**Proposed Crematorium Highway Improvements
Grevatt's Lane West, Bilsham, Yapton, West Sussex**

ROAD SAFETY AUDIT STAGE 1
16th September 2019

PBA drawing 128.001.007 Rev D

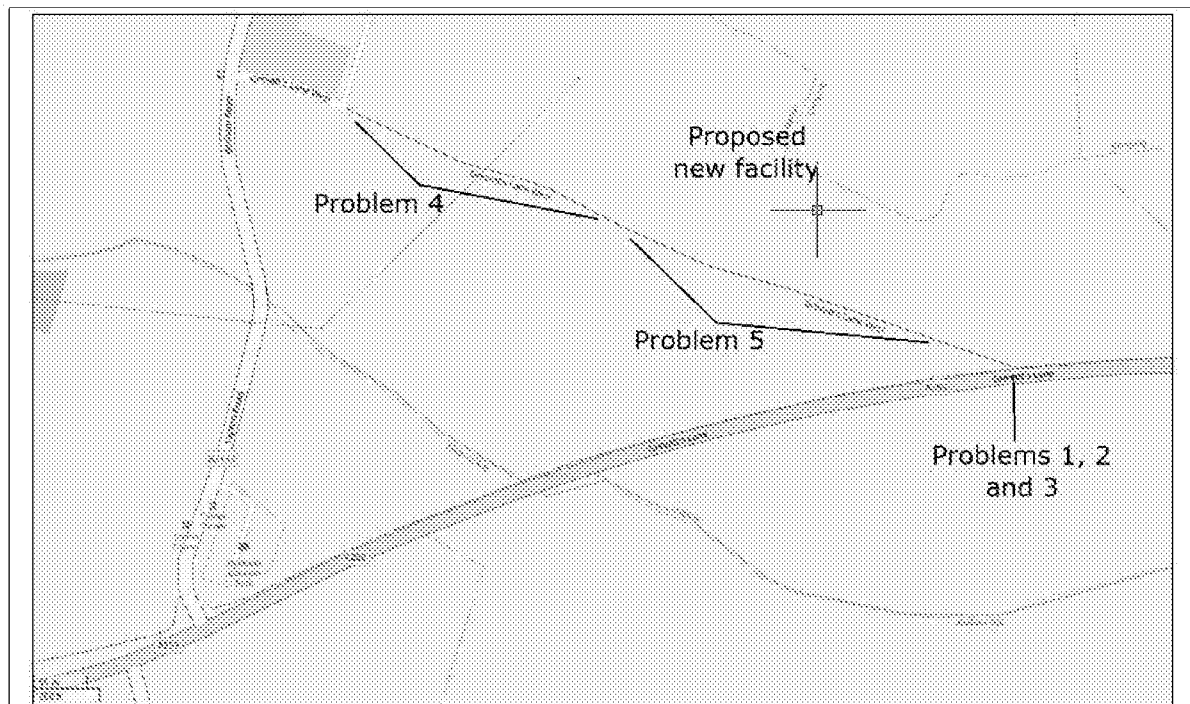
Summary: It may not be evident to other vehicles why some vehicles, particularly eastbound, are slowing to turn left into Grevatt's Lane West. This could result in rear end shunt collisions on the main road.

Summary: The provision of the new junction on the A259 may lead some drivers to believe there is access to the B2132 Bilsham Road. Drivers exploring this route will then have to reverse their route when they meet the proposed bollard at the crematorium entrance. Attempting to reverse their route within the improved section may lead to collisions.

Summary: On the preliminary design layout the tactile paving appears to be offset from the substantive through route of the shared path. Pedestrians, particularly those who are blind or partially sighted may therefore continue their established direction and 'miss' the tactile paving and continue across the junction with the risk of collision with turning vehicles.

It is unclear from the preliminary design if a footway is to be provided as part of the improvement from the A259. If not, then pedestrians who choose to access the new facilities from the A259 will be required to use the 400m carriageway with risk of collision with vehicles.

Recommendation: Provide traffic signing, preferably worded directional signs 'Crematorium', to give notification to drivers on the A259 of the facility. Such signing would also provide useful information to visitors from outside of the local area.

Recommendation: Consider the provision of no through road signs (TSRGD diag 816) at the A259 junction.

Recommendation: Discuss with West Sussex County Council (Highway Authority) and provide additional details on the facilities for pedestrians. Consider the re-

alignment of the existing shared use path at a point further back from the proposed junction.

Recommendation: Review the design of the track improvement and the provision of facilities for pedestrians.
